CITY OF
West Linn
 PLANNING AND DEVELOPMENT

**STAFF REPORT
 PLANNING MANAGER DECISION**

DATE: August 23, 2018
 FILE NO.: MIP-17-06
 REQUEST: Approval of a two-parcel minor partition at 18902 Walling Circle
 PLANNER: Peter Spir, Associate Planner

EXHIBIT E: APPROVED TENTATIVE PLAN (SHEET 4 OF 7)

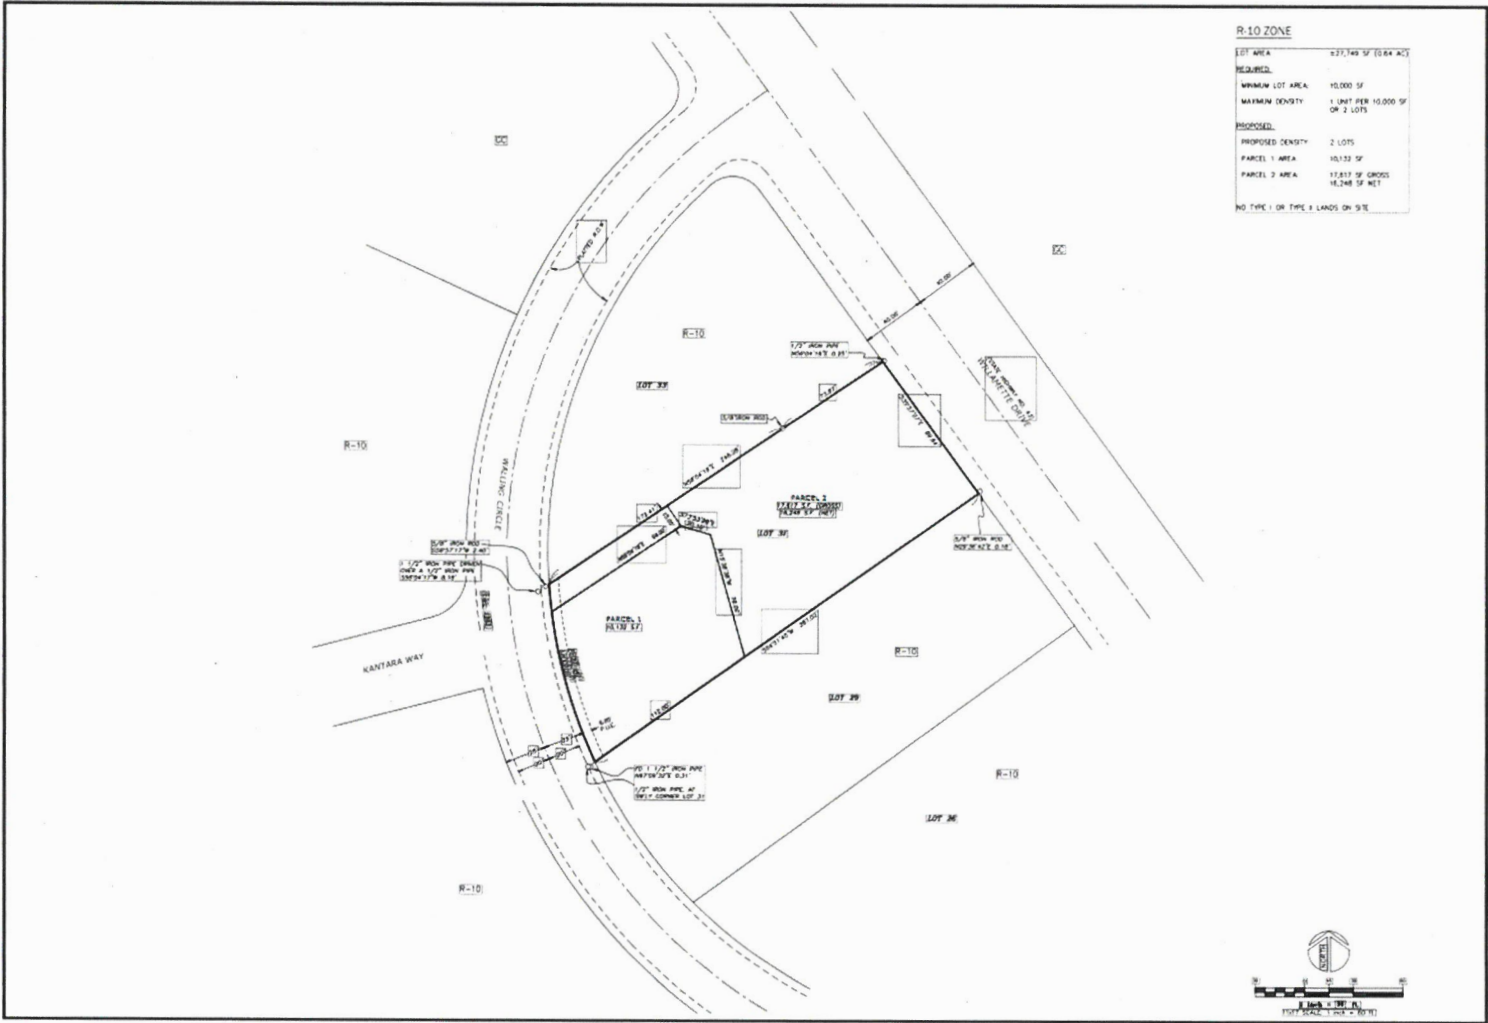
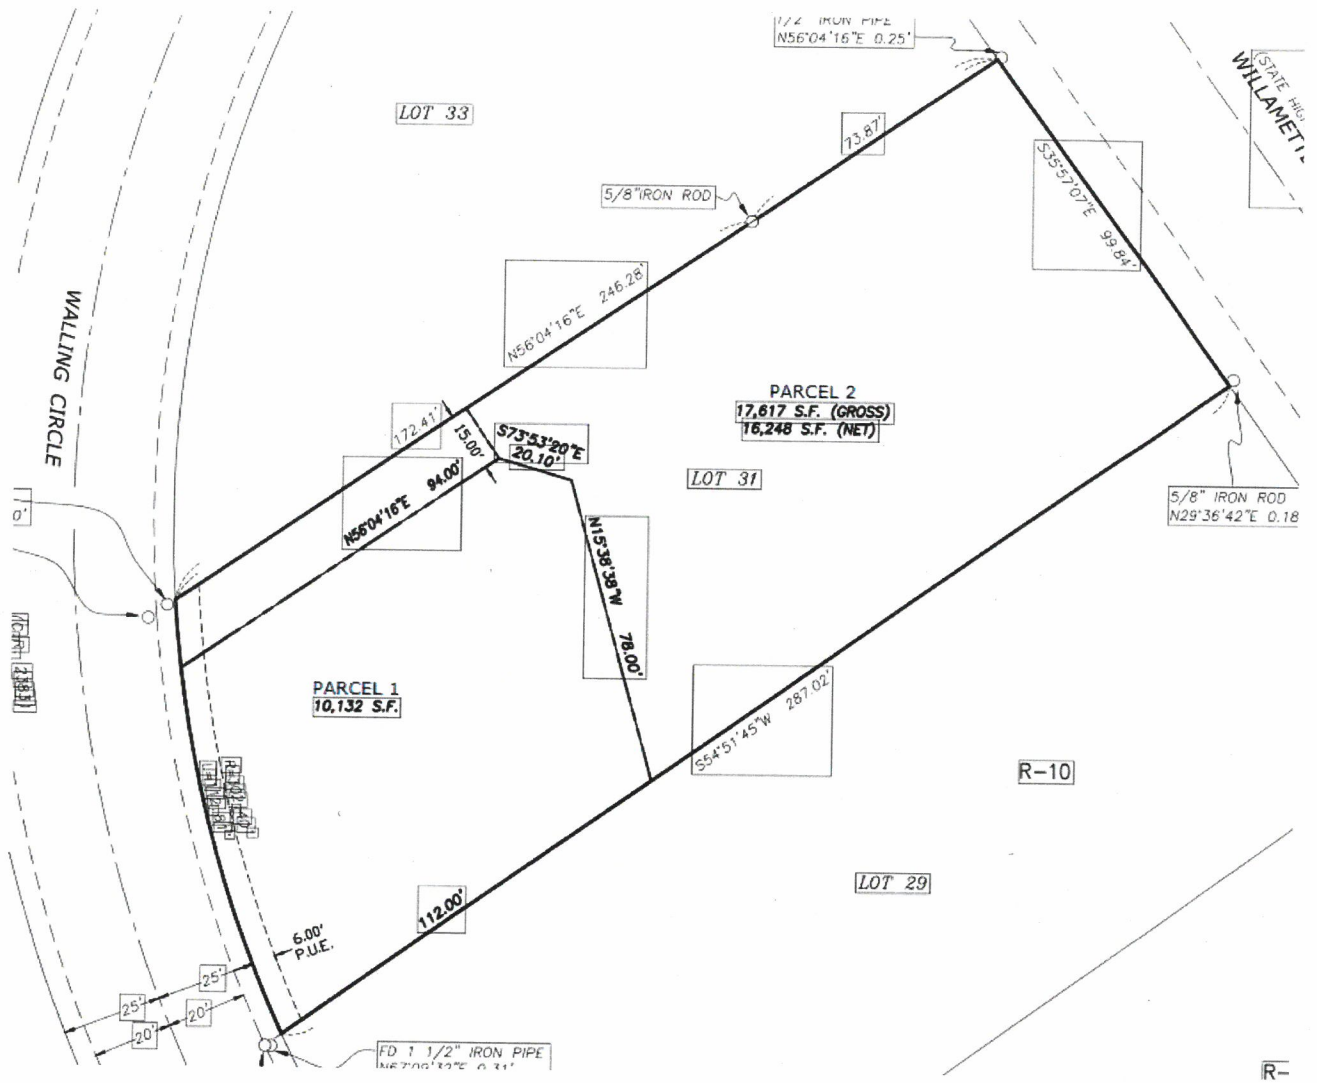
Access to parcel 2 from Walling Circle is proposed via a 12 foot wide paved driveway in a 15 foot wide flag lot stem. To meet side yard setbacks, a 15 foot wide access easement is required instead of the flag lot stem.

Staff Finding 3: With one exception, the applicant’s proposal meets all lot dimensional requirements. The exception is that the applicant’s use of a flag stem requires a 7.5 foot side yard setback from all portions of the existing house to the proposed flag lot stem. As shown, the setback from the flag lot stem to the house is 6.5 feet and the setback to the stairs and deck is 2.7 feet. (See detail on Sheet 3 of 7.) In cases where the location of the existing house compromises the ability to meet the setback, the applicant may replace the flag lot stem with an access easement per 85.200(B) (7) (f). By using an access easement, the side yard setbacks are met. (Setbacks will be measured from the north property line so the stairs will have a side yard setback of 18 feet and the house will have a side yard setback of 22 feet.) The criteria is met by Condition of Approval 5.

Staff Finding 17: Sheet 4 of 7 indicates that the access easement/stem was not counted in the net lot sizes. After excluding 1,369 square feet for the access easement/stem, parcel 1 has 10,132 square feet and parcel 2 has 16,248 square feet which meets the R-10 (10,000 square foot) minimum lot size. By condition of approval 5, the criteria is met.

Staff Finding 19: The applicant proposes to access parcel 2 via a 15 foot wide flag lot stem. As explained in Staff Finding 1, the flag lot stem configuration can only work if there is room for the 15 foot flag lot stem width plus a 7.5 foot side yard setback to the existing house. Referring to Sheet 3 of 7, the existing ranch style home and side stairs cannot meet the side setback. Consequently, the tentative plan needs to be modified to eliminate the flag lot stem and replace it with an access easement. The criteria is met by Condition of Approval 5.

1. **Site Plan.** With the exception of modifications required by these conditions, the final plat shall conform to the submitted Tentative Plan (Sheet 4 of 7).

5. **Access and Maintenance Easement.** The final plat shall not show a flag lot stem. Instead, a 15 foot wide access easement shall be established which will also include a maintenance easement to allow the property owner of parcel 2 to make any needed repairs on the driveway within that easement. (Any structures that encroach on the access easement shall be removed prior to final platting.)

PSIT **6** of 7

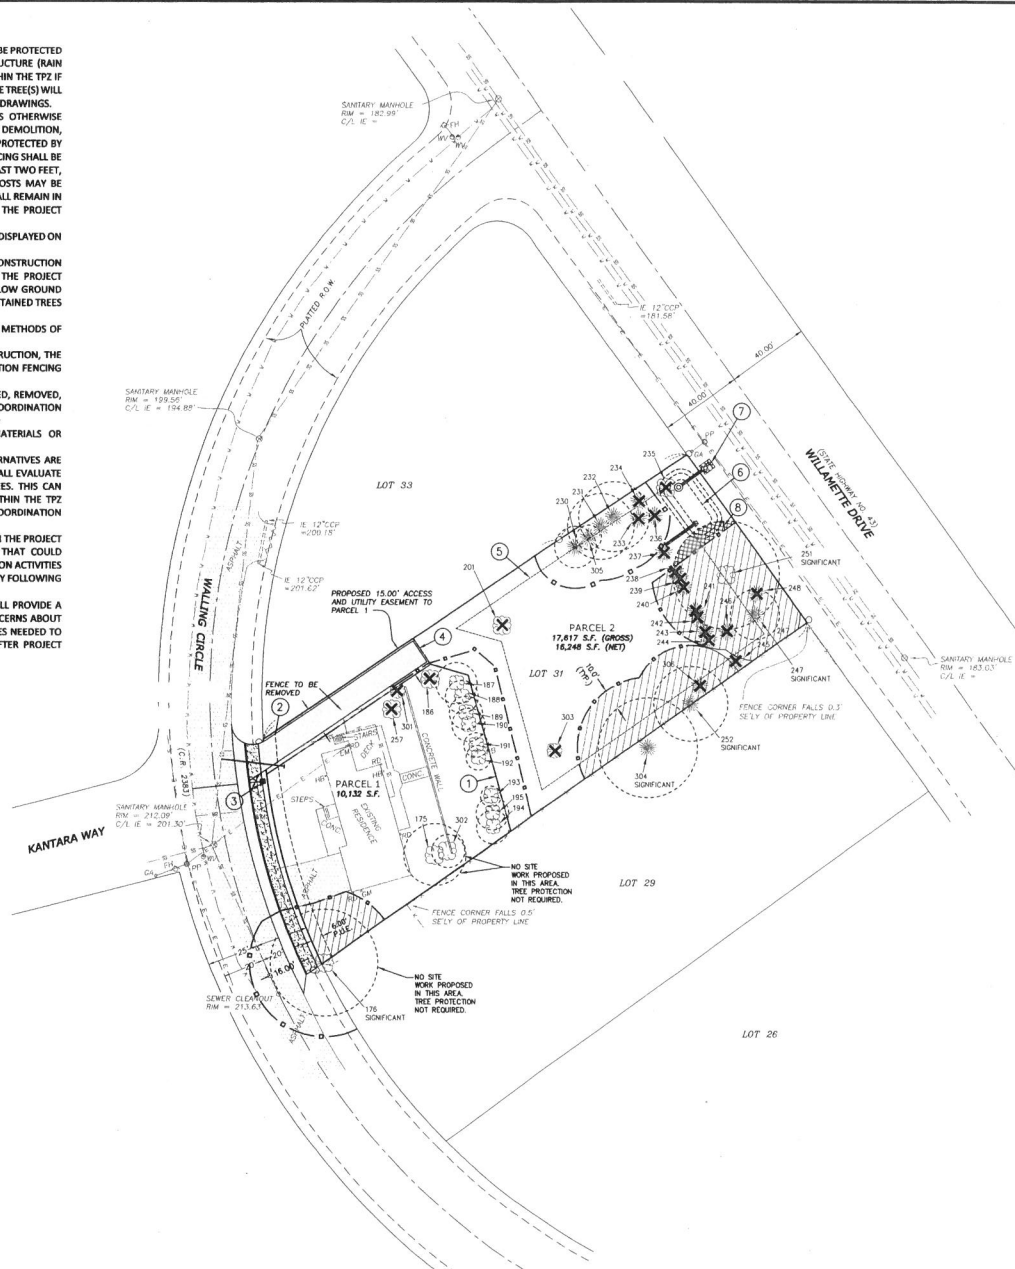
The applicant's grading plan (Sheet 6 of 7) indicates that the north edge of the driveway will require a retaining wall approximately 1-2 feet high. Because of the surcharge of the driveway, the retaining wall and footings must be designed by an Oregon licensed engineer and must provide storm water collection and disposal. Building Code standards do not allow storm water to sheet or runoff to the neighbor's property. Instead, runoff must be directed to an approved discharge point (e.g. the curblin on Walling Circle, a raingarden, etc.). The final design and construction of the retaining wall, driveway and storm water collection and disposal will be reviewed by the Building Official concurrent with the building permit application for Parcel 2. If the applicant is able to develop a grading plan that accommodates the driveway without a retaining wall, the same Building Code standards prohibiting storm water to sheet or runoff to the neighbor's property would apply.
